Cheng Yi Garments Industries Ltd

Holding-E/44, Ward No-15, Vogra, Bashan Sarak, National University, Gazipur -1704.

12 May 2026

4. Observation

Roof top prayer room & 6th floor phased construction marked in Red

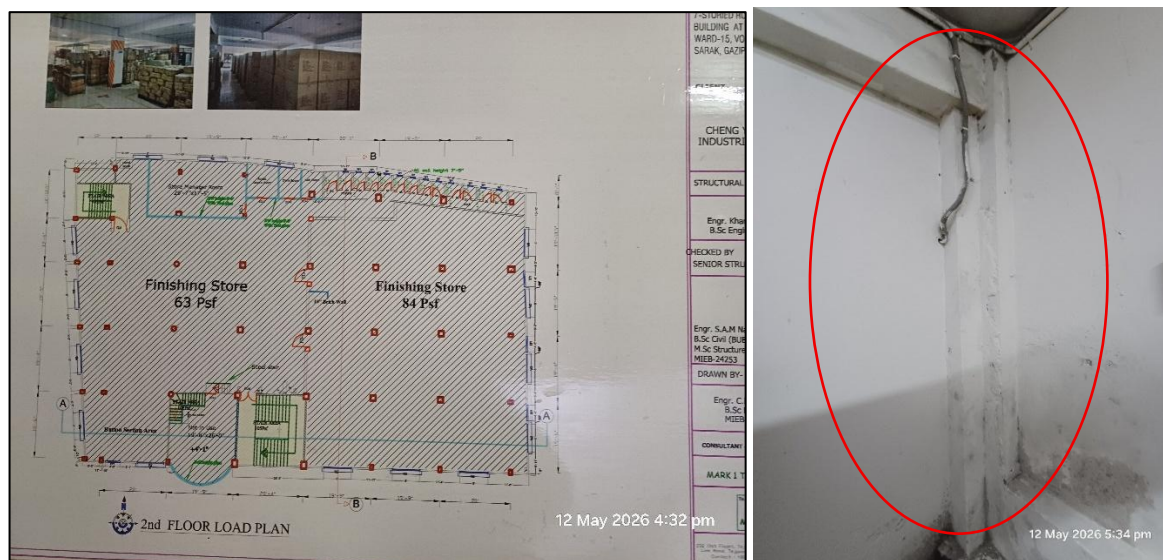
Observation-02: Lack of information in DEA documents (including DEA report, details of phased construction) of the Production Building.

Description: The building was constructed in two phases. However, no such information has been included in the DEA report. Also, a detailed review is required for lateral loadings and serviceability requirements.

- The building engineer is required to incorporate the necessary information for phased construction & review the DEA, seismic requirements, framing system, and incorporate necessary measures (if necessary) as per Section 1.3.4; Section 1.3.5; Section 1.5.4.2; Section 1.5.4.3 & Section 2.5.5 of BNBC 2006 and update the analysis and design report in accordance with Section 1.9.1 of BNBC 2006.
- Also, the building engineer is required to incorporate necessary remedial works (if required).

(Scan of RC2 Column short face, at Grid Point J8 of 4th floor)

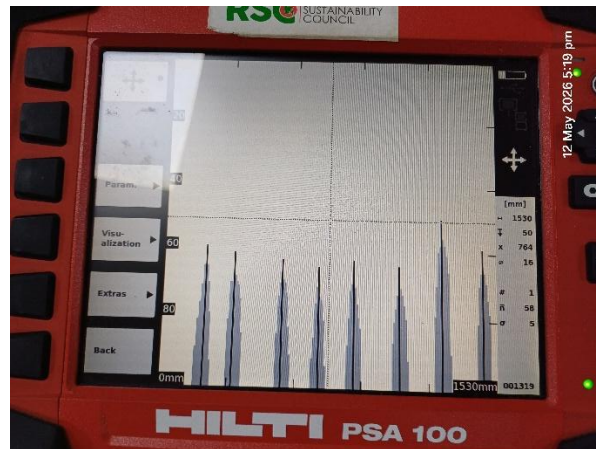
- main rebar found 8 nos instead of 12 nos in C1 column at 2nd floor level grid location 3L
- main rebar found 8 nos instead of 12 nos in C4 column at 2nd floor level grid location H4
- main rebar found 3 nos in short direction instead of 4 nos in RC2 at 4th floor level grid location J8
- main rebar found 10 nos instead of 12 nos in C4 column at 5th floor level grid location K4

The building engineer is required to survey the as-built condition of whole structure, prepare an accurate set of as-built drawings (including verification of foundation size and thickness; verification of column & beam rebar), and submit them to RSC for review.

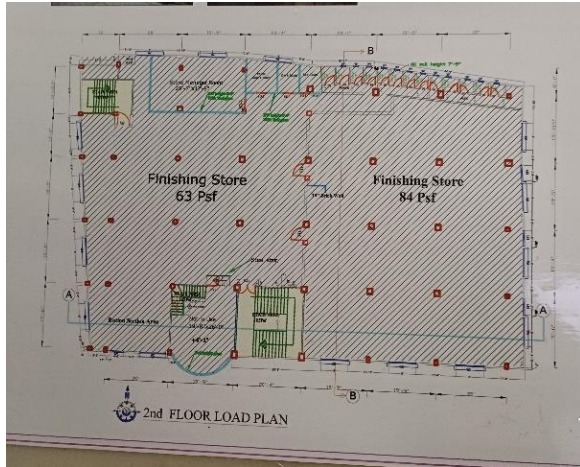
Description: The thickness and height of the brick wall, the floor build-up, and the false slab thickness are not shown appropriately in the drawing.

In addition, the detailed dimensions of the wall, wall thickness, and cantilever extension length are not shown clearly in the drawings.

Moreover, the landing beam was found to be tapered (depth variation) on site.
